# MEMORANDUM

**SUBJECT:** Continuation of a public hearing and consideration of an application for a Landmark Alteration Certificate to construct a 1,459 sq. ft. addition to the main house, to relocate an existing garage on the property, and to construct a 330 sq. ft. one-car garage at 711 Pine St. in the Mapleton Hill Historic District, per section 9-11-18 of the Boulder Revised Code 1981 (HIS2014-00172).

1. Site: 711 Pine St.
2. Zoning: RL-1 (Residential-Low 1)
3. Lot size: 10,323 sq. ft.
4. Existing House: 990 sq. ft.
5. Proposed Addition: 1,459 sq. ft.
6. Existing Garage: 245 sq. ft.
7. Proposed Garage: 330 sq. ft.
8. Applicant/Owner: David Waugh, Kevin Deighan
9. Date of Construction: 1939

Figure 7. July 2<sup>nd</sup>, 2014 (left) and Proposed Site Plans (right). Not to scale.

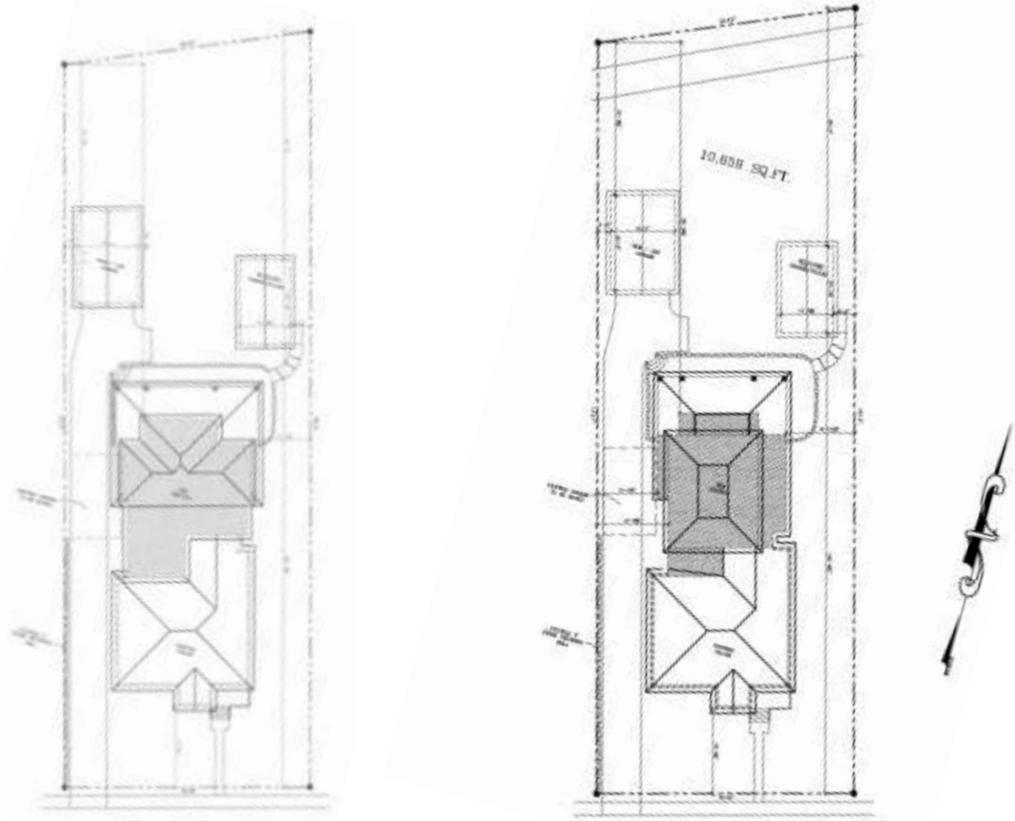
Drawings show a 1,459 sq. ft. addition to be constructed at the rear of the existing 990 sq. ft. house. The first floor is shown to be 909 sq. ft. and the second floor to 550 sq. ft. in size. The garage currently takes access from the street as the property does not border an alley. This condition is proposed to be maintained with the relocation of the existing garage and construction of a new garage at the west side of the property.

The proposed floor area of the house is calculated to be approximately 2,449 sq. ft. with the estimated lot coverage estimated at 1,899 sq. ft. on the 10,323 sq. ft. lot. The application states with the existing and proposed garage, the total floor area (FAR) for the proposal to be 3,024 sq. ft. where the maximum floor area for this property is 4,180 sq. ft.

Figure 22. Proposed new garage and relocated garage/studio.

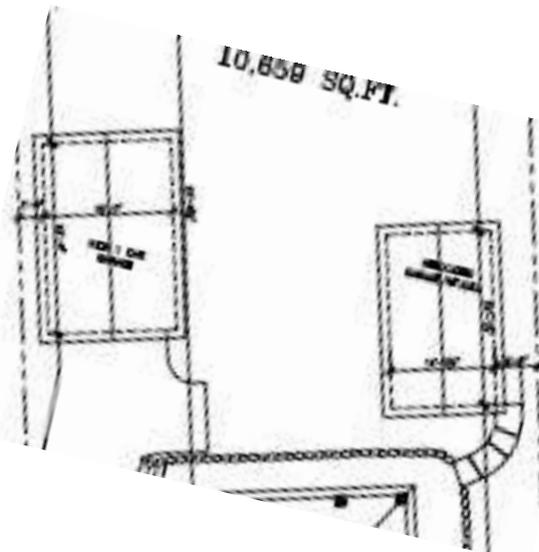
Plans call for the existing 245 sq. ft. garage to be relocated from the west side of the lot to the east side and to be used as a studio. Other than relocation, no changes are shown to be made to the existing garage. A new one car garage of 330 sq. ft. will be constructed behind the house by the west fence line. Because of the slope of the lot, the simple gable end building is shown to be bermed into the ground at the north. Fenestration consists of a simple wood automobile door at the south with a man door and single light casement window on the east face of the building. Plans call for the new building to be sheathed in wood clapboard siding and board and batten to match the proposed addition.

Figure 23. South and East Elevations of proposed garage.

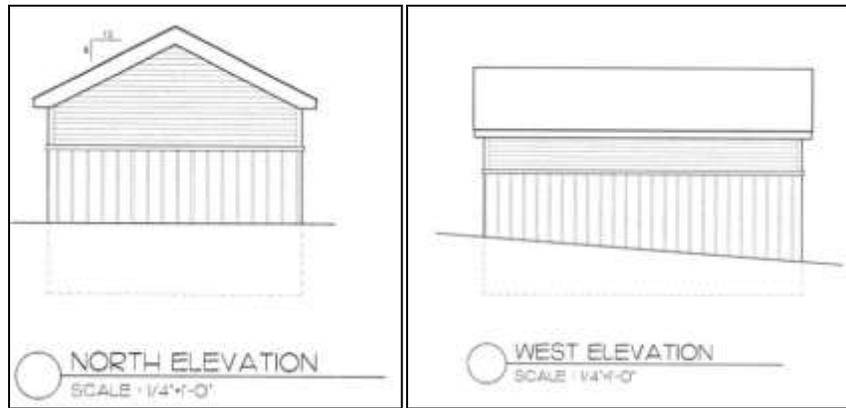
<i>on the property, but be subordinate to it in terms of size and massing.</i>	are appropriate.	
.6	<i>New garages for single-family residences should generally be one story tall and shelter no more than two cars. In some cases, a two-car garage may be inappropriate.</i>	Proposed one-car garage is one-story tall. Massing proportionate to built mass and open space on property.	<b>Yes</b>
.7	<i>Roof form and pitch should be complementary to the primary structure.</i>	Roof form is complementary to the main house.	<b>Yes</b>
<b>Materials and Detailing</b>			
.8	<i>Accessory structures should be simpler in design and detail than the primary building.</i>	As shown, garage is simpler than main house in design, material, and detailing.	<b>Yes</b>
.9	<i>Materials for new garages and accessory structures should be compatible with those found on the primary structure and in the district. Vinyl siding and prefabricated structures are inappropriate.</i>	Proposed materials (wood siding, windows, and doors) will be compatible with character of historic district. Consider using not using only clapboard siding (see 2.3.3 above). Resolve at Ldrc.	<b>Maybe</b>

.10	<i>Windows, like all elements of accessory structures, should be simpler in detailing and smaller in scale than similar elements on primary structures.</i>	Proposed design of windows on east and elevation appears to be compatible in terms of window type, size and detailing with similar elements on the primary building.	<b>Yes</b>
.11	<i>If consistent with the architectural style and appropriately sized and located, dormers may be an appropriate way to increase storage space in garages.</i>	N/A	<b>N/A</b>
.12	<i>Garage doors should be consistent with the historic scale and materials of traditional accessory structures. Wood is the most appropriate material and two smaller doors may be more appropriate than one large door.</i>	Garage doors appear to be consistent in terms of scale and materials. Review final details at Ldrc.	<b>Maybe</b>
.13	<i>It is inappropriate to introduce features or details to a garage or an accessory building in an attempt to create a false historical appearance.</i>	Proposed design does not attempt to recreate a false historic appearance.	<b>Yes</b>
